URBAN DESIGN COMMISSION APPLICATION

SHEET LIST - ARCHITECTURAL	
SHEET NUMBER	SHEET NAME
PR0.0	COVERSHEET FOR PROPOSED CHANGES
PR1.1	BUILDING 1 & 2 PROPOSED CHANGES - FLOOR PLAN
PR1.2	BUILDING 1 & 2 PROPOSED CHANGES - ELEVATIONS
PR1.3	BUILDING 1 & 2 PROPOSED CHANGES - ELEVATIONS
PR1.4	BUILDING 1 & 2 PROPOSED CHANGES - ELEVATIONS
PR1.5	BUILDING 1 & 2 PROPOSED CHANGES - ELEVATIONS
PR1.6	BUILDING 1 & 2 PROPOSED CHANGES - ELEVATIONS
PR2.1	BUILDING 3 PROPOSED CHANGES - FLOOR PLAN
PR2.2	BUILDING 3 PROPOSED CHANGES - ELEVATIONS
PR2.3	BUILDING 3 PROPOSED CHANGES - ELEVATIONS
PR2.4	BUILDING 3 PROPOSED CHANGES - ELEVATIONS
PR3.1	BUILDING 4 PROPOSED CHANGES - FLOOR PLAN
PR3.2	BUILDING 4 PROPOSED CHANGES - ELEVATIONS
PR3.3	BUILDING 4 PROPOSED CHANGES - ELEVATIONS
PR3.4	BUILDING 4 PROPOSED CHANGES - ELEVATIONS
PR3.5	BUILDING 4 PROPOSED CHANGES - ELEVATIONS

MULTI-FAMILY HOUSING
THE MEADOWLANDS
MADISON, WI
KCG HOUSING DEVELOPMENT

THE MEADOWLANDS - PROPOSED SITE PLAN CHANGES

2 NORTH ELEVATION - BLDG 3 - PROPOSED DESIGN
PR2.3 1/8" = 1'-0"

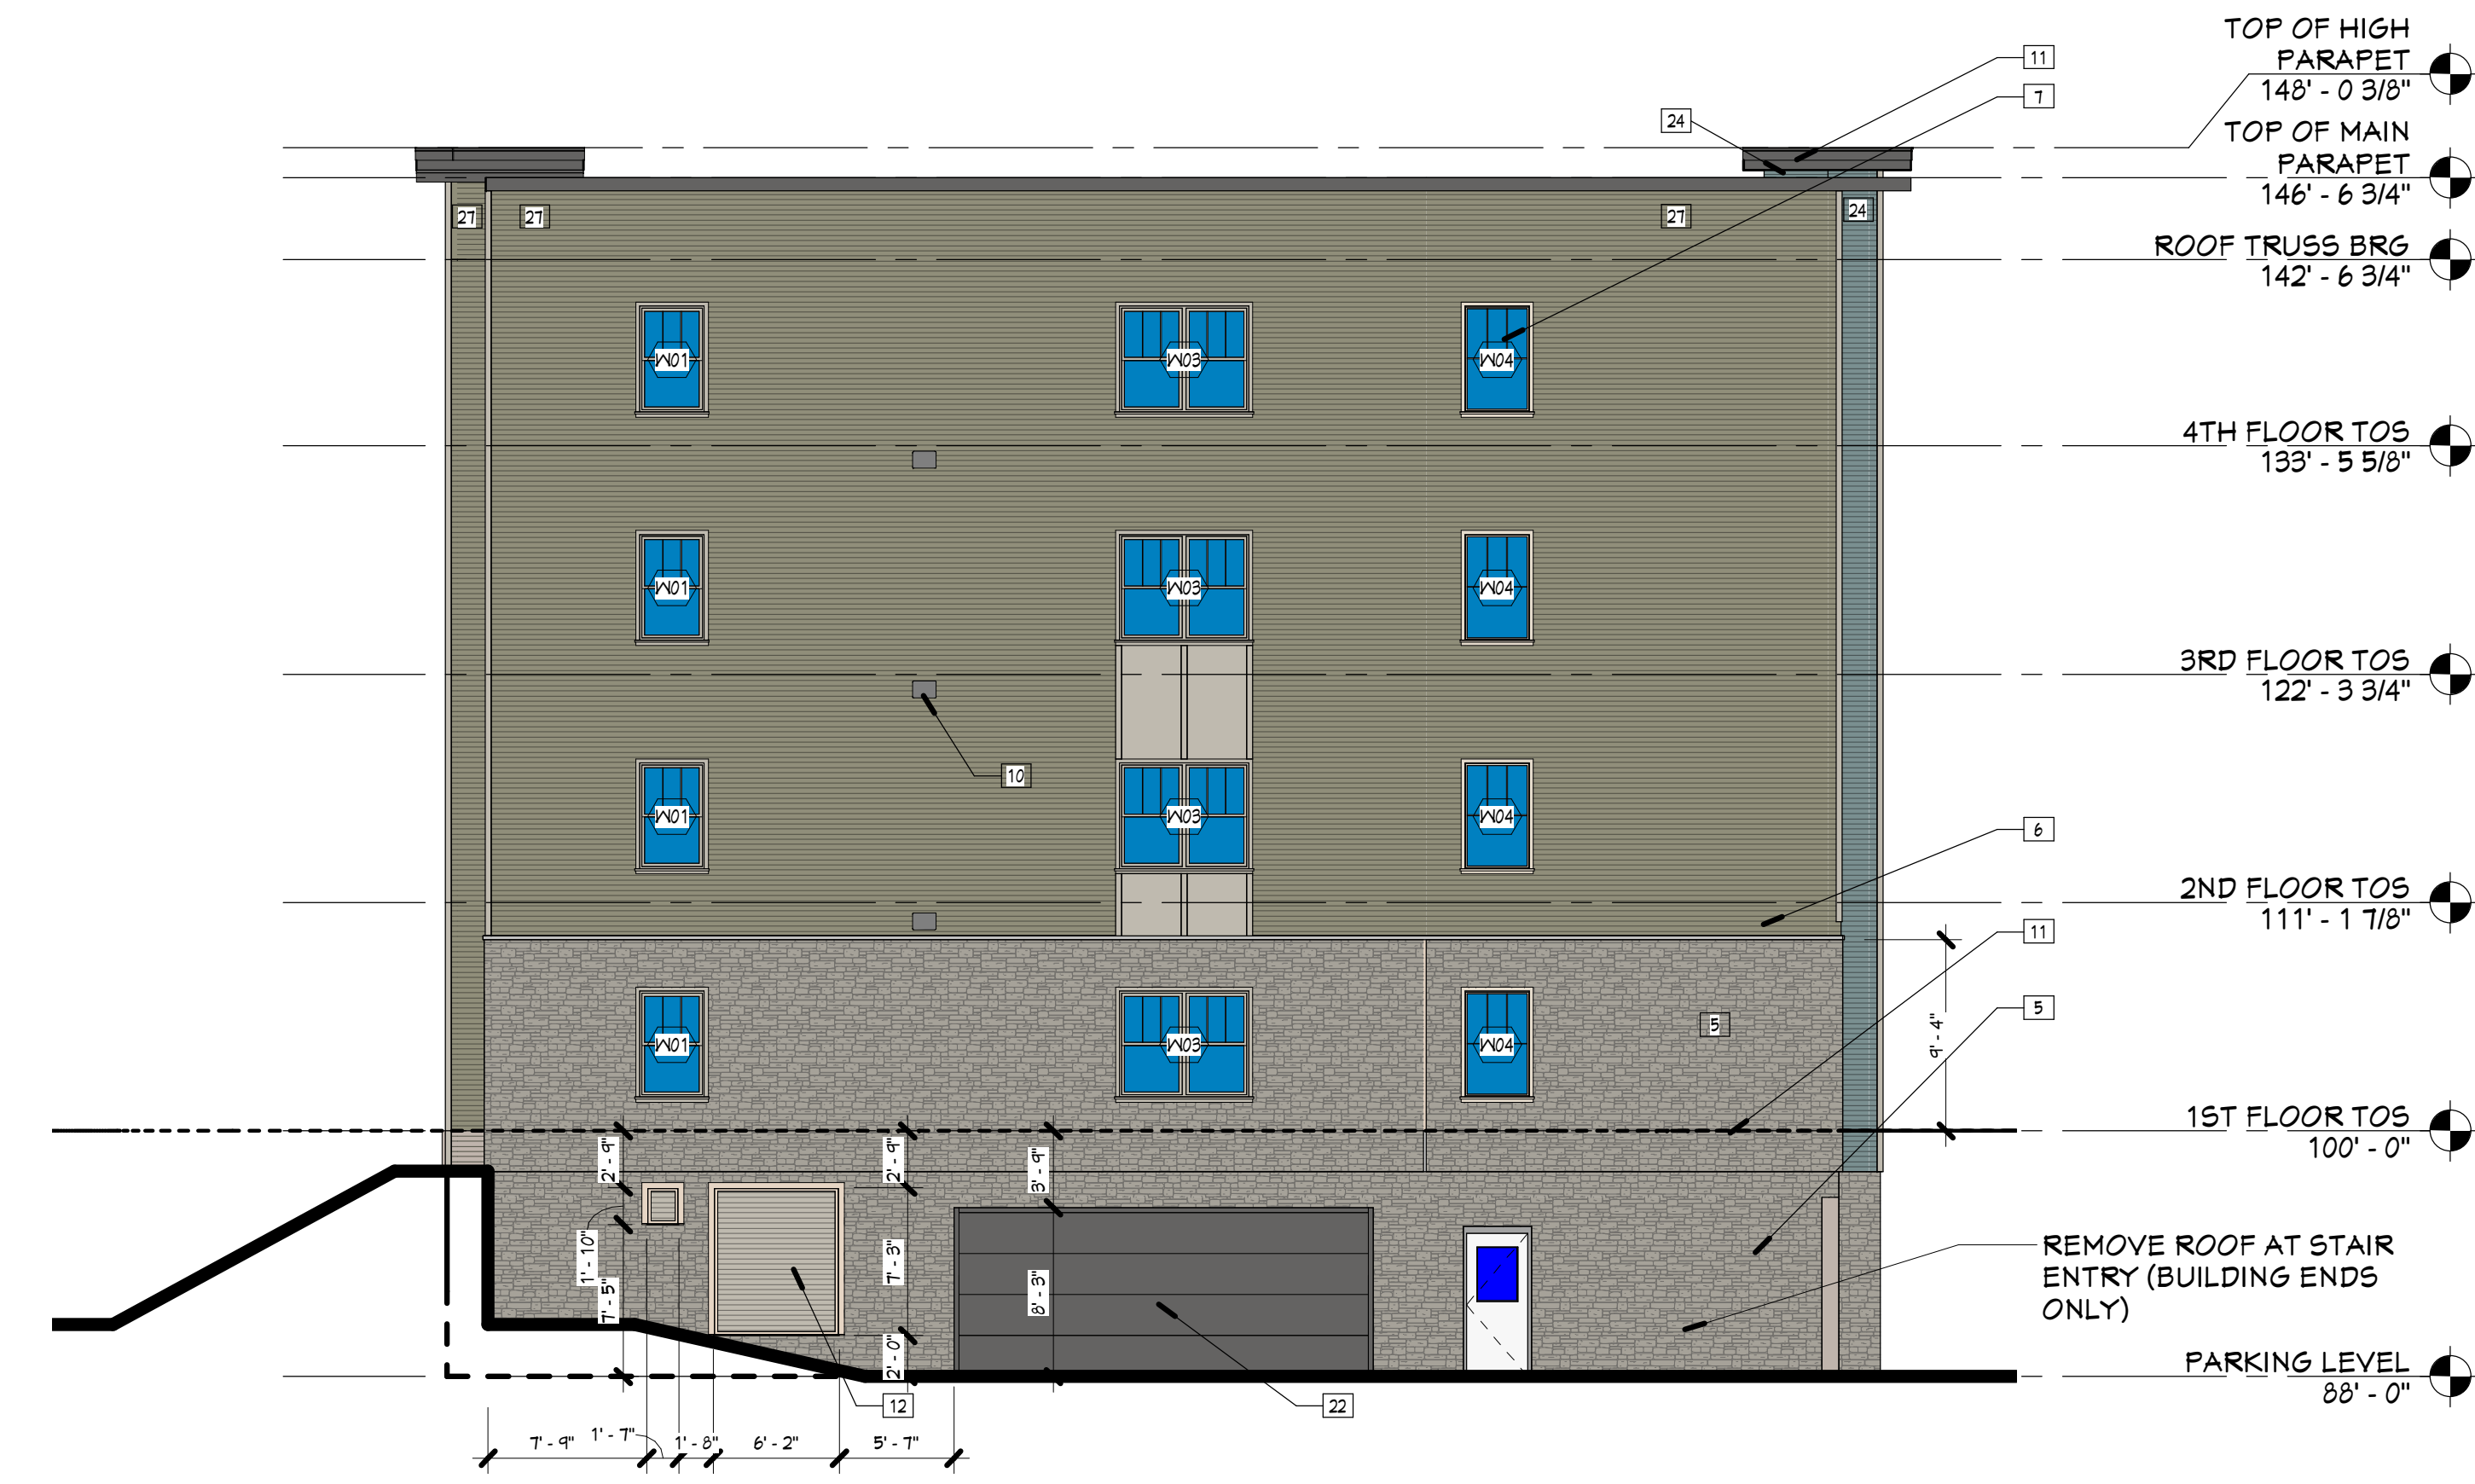
1. REMOVE STEPS TO FIRST FLOOR PRIVATE PATIOS AND ASSOCIATED SIDE WALKS.
2. DECORATIVE SCONCES REMOVED (LIGHTING PLACED IN SOFFIT ABOVE WHERE APPLICABLE)

1 EAST ELEVATION - BLDG 3 - PROPOSED DESIGN
1/8" = 1'-0"

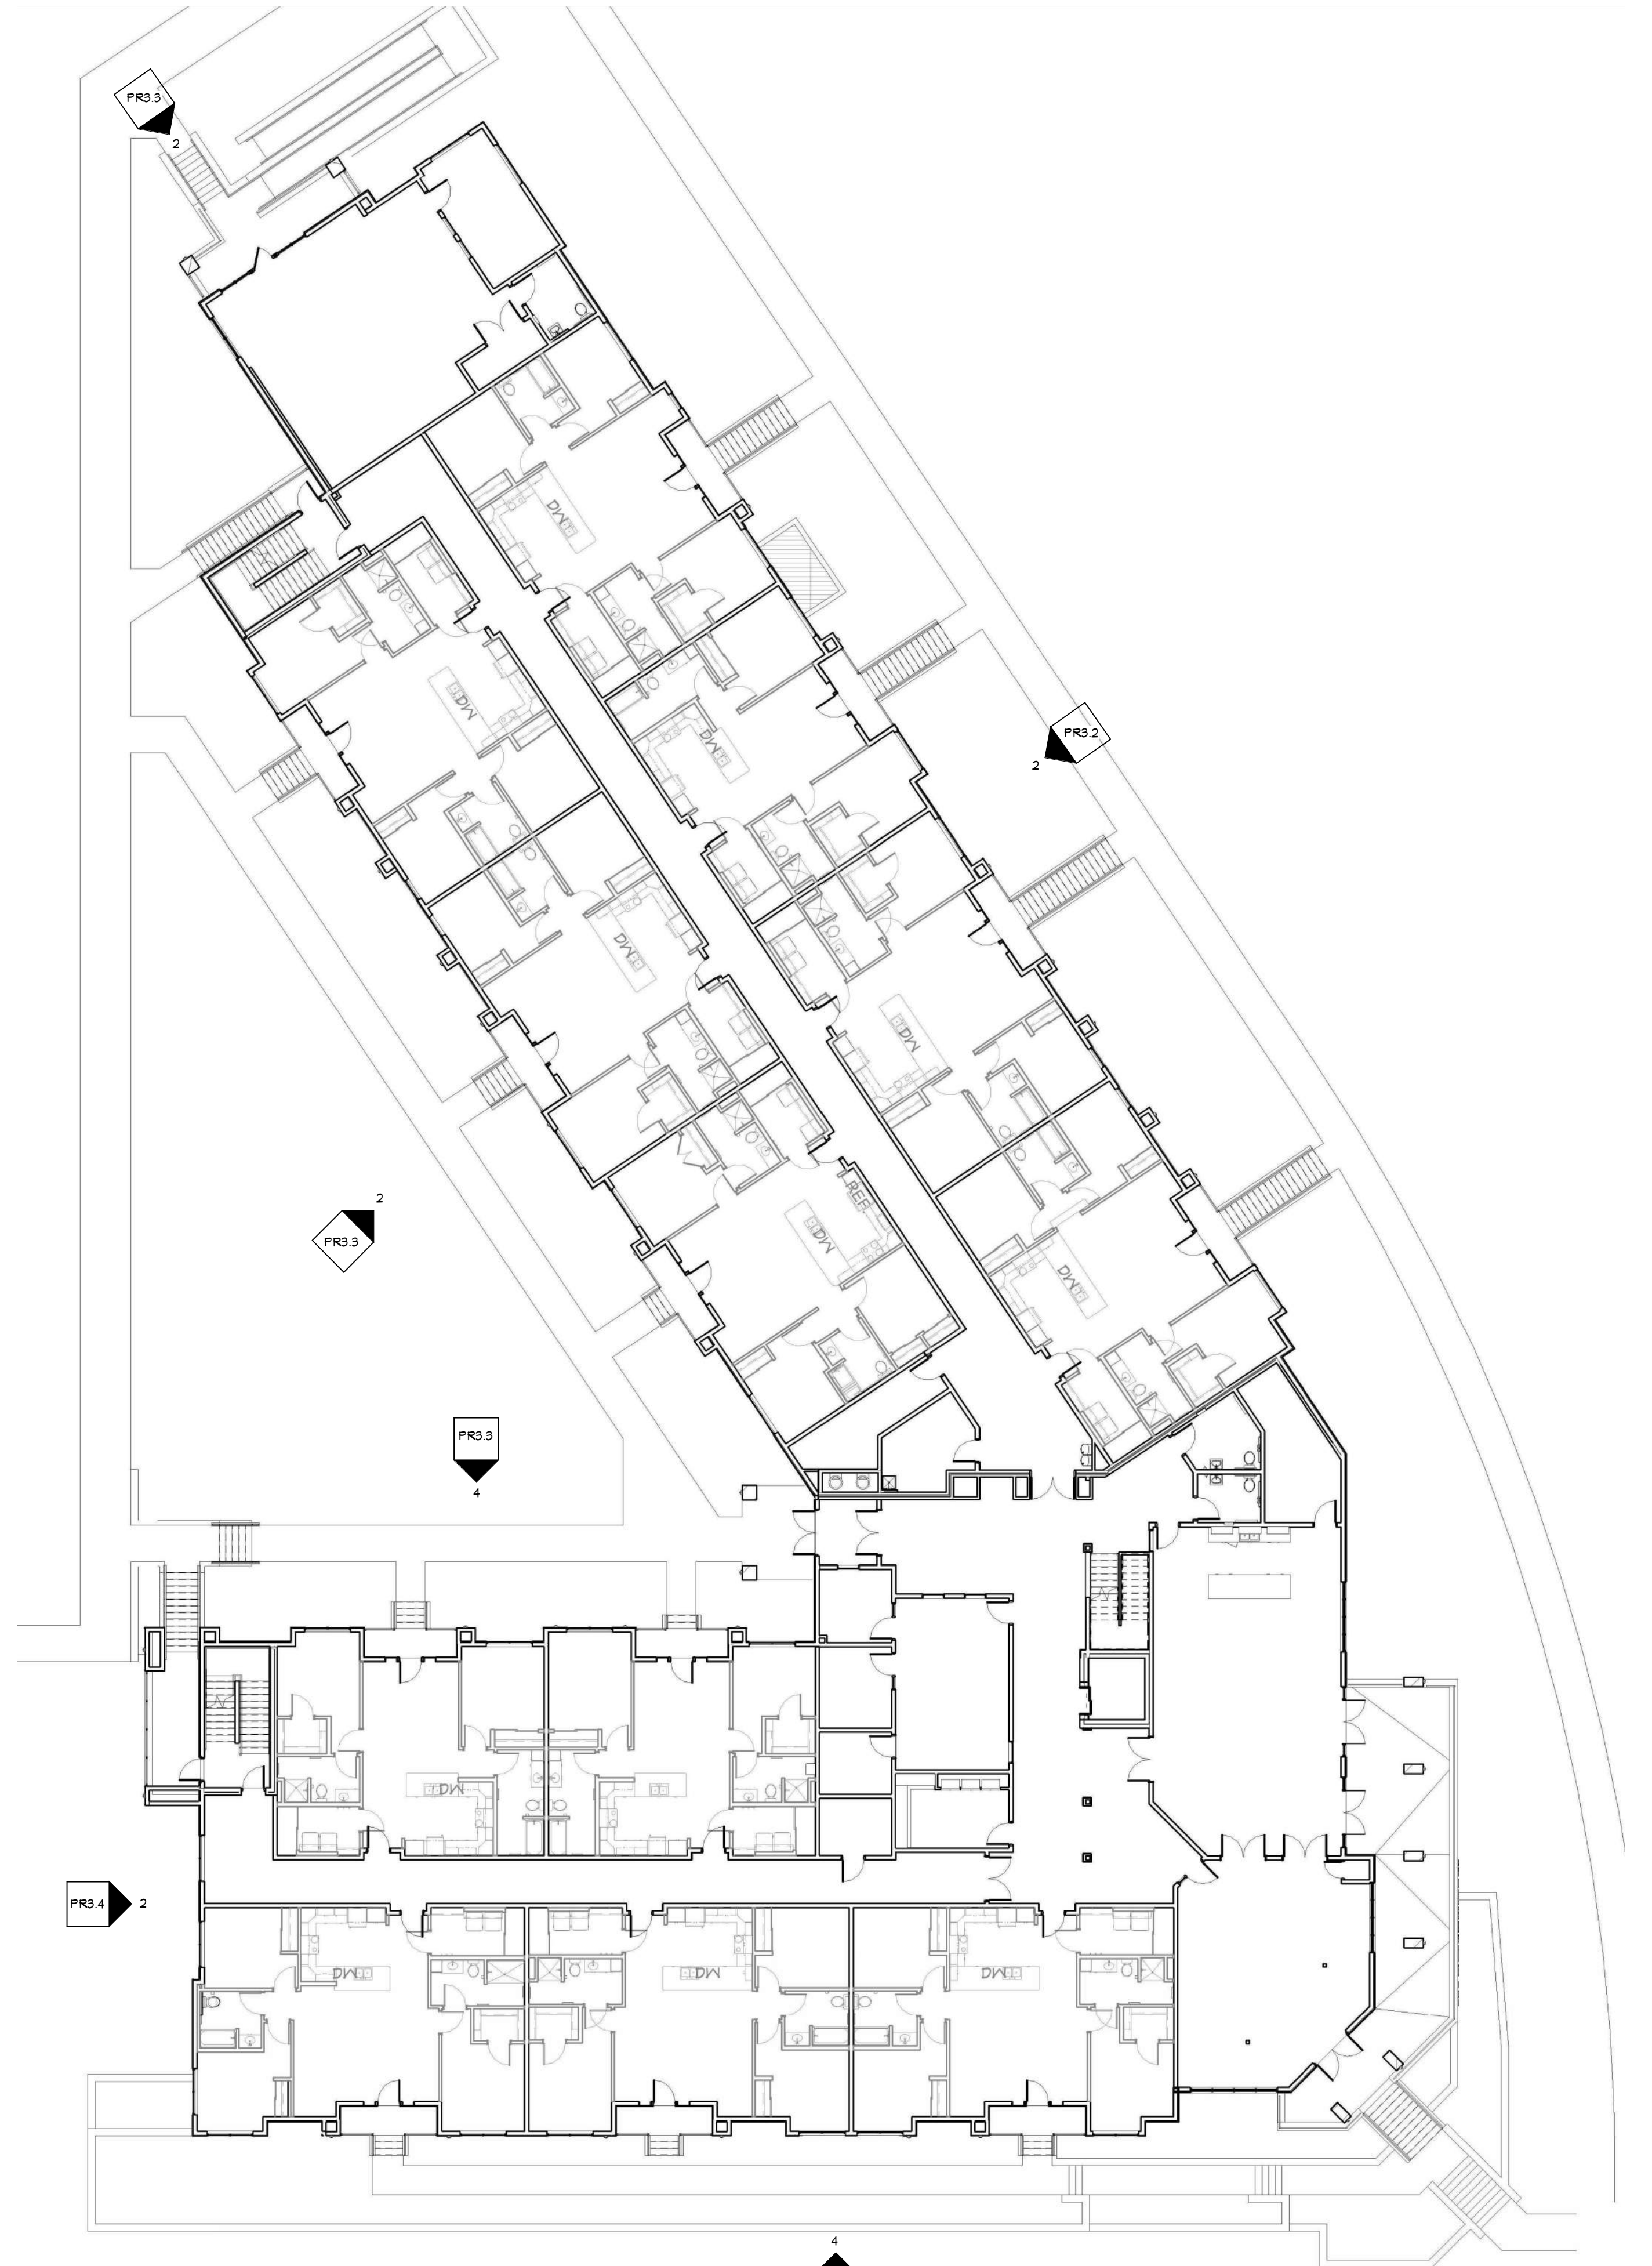
1. REMOVE STEPS TO FIRST FLOOR PRIVATE PATIOS AND ASSOCIATED SIDE WALKS.
2. DECORATIVE SCONCES REMOVED (LIGHTING PLACED IN SOFFIT ABOVE WHERE APPLICABLE)
